# CITY OF ALBUQUERQUE

**Re: RGPU Marble  
1201 San Pedro Dr. NE  
30-Day Temporary Certificate of Occupancy  
Transportation Development Final Inspection  
Engineer's/Architect's Stamp dated 5-22-20 (J18D008)  
Certification dated 10-30-20**

RGCU Marble  
1201 SAN PEDRO DR. NE  
ALBUQUERQUE, NM 87110

A1 SITE PLAN  
SCALE: 1" = 10'

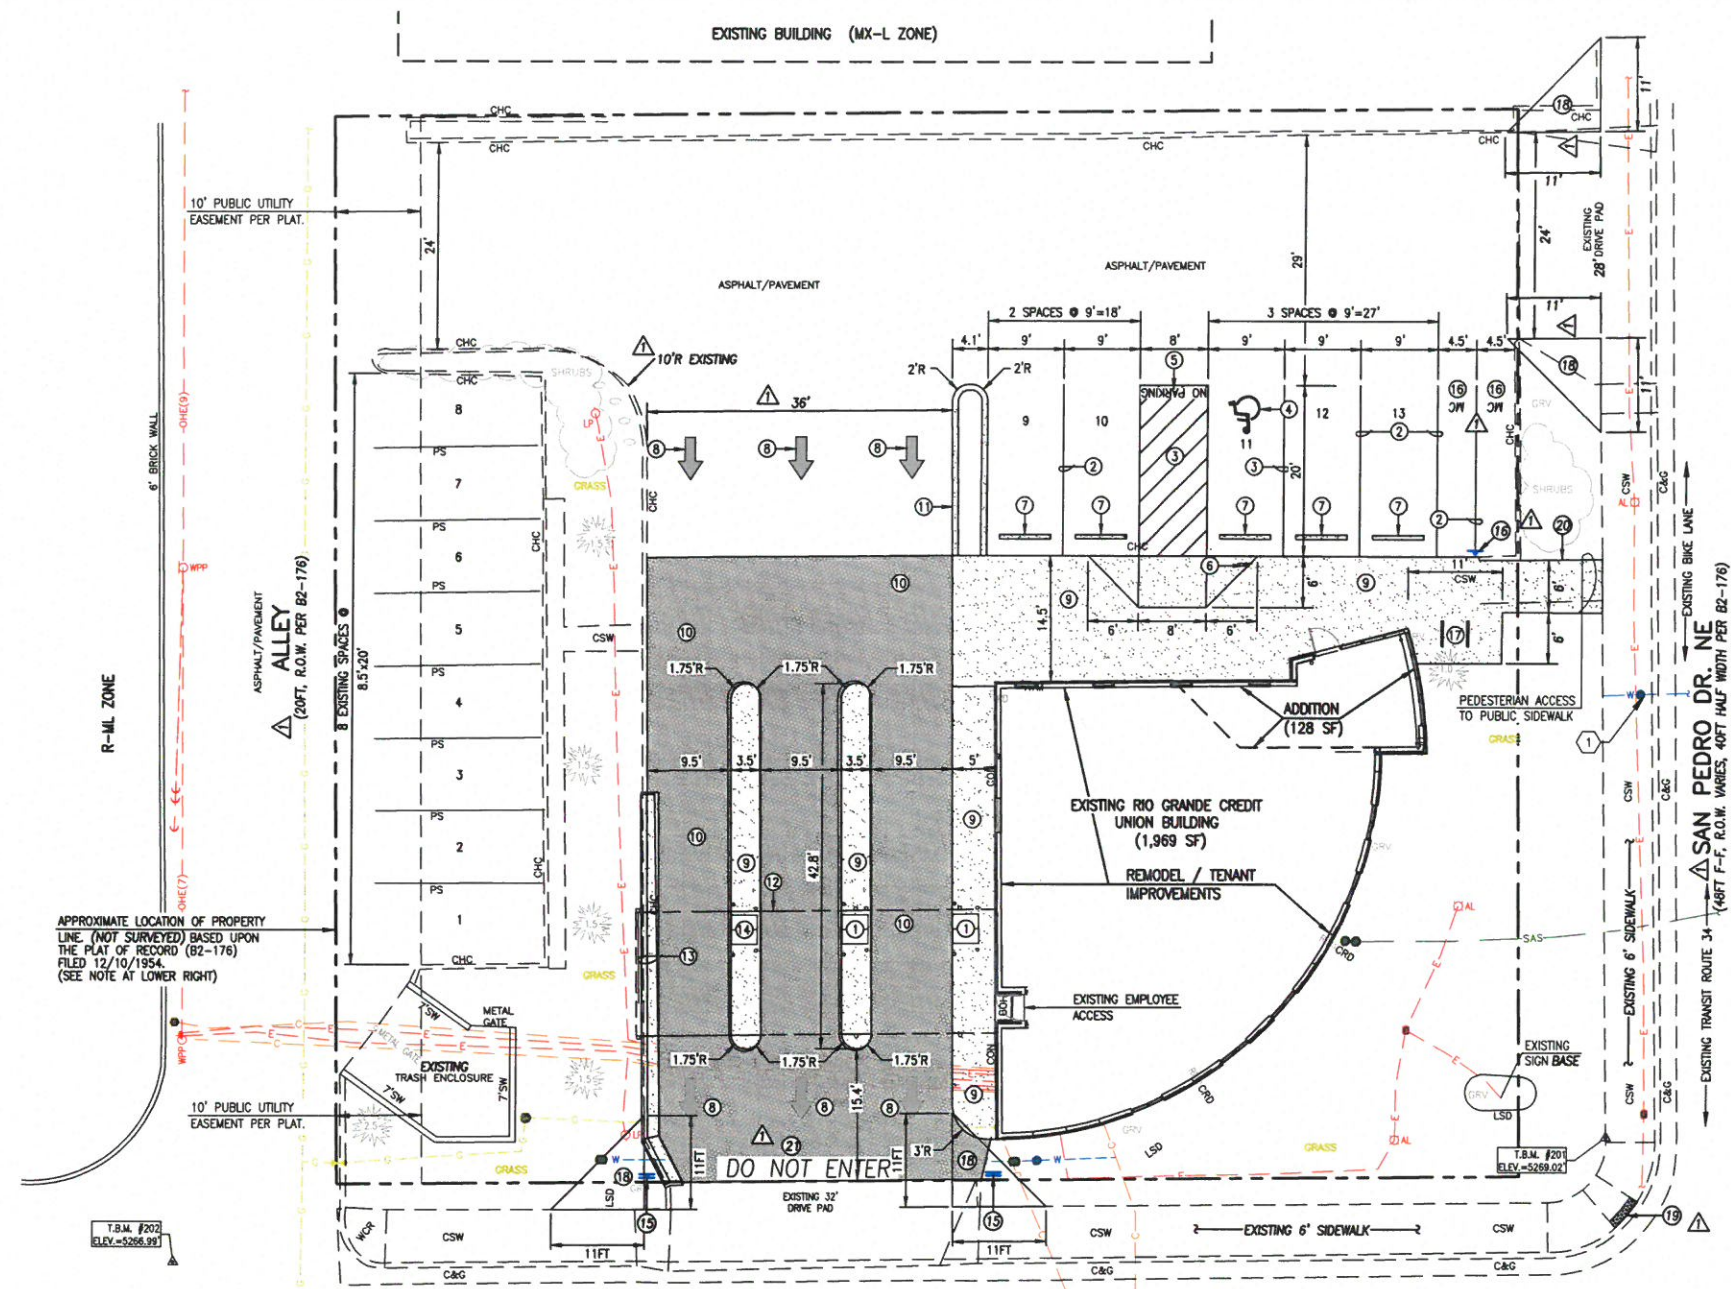
- Please correct cracked broken sidewalk.
- Please remove construction debris and materials from site.

Once these corrections are complete, email pictures showing the changes to [PLNDRS@cabq.gov](mailto:PLNDRS@cabq.gov), and [epgomez@cabq.gov](mailto:epgomez@cabq.gov) for release of Final CO.
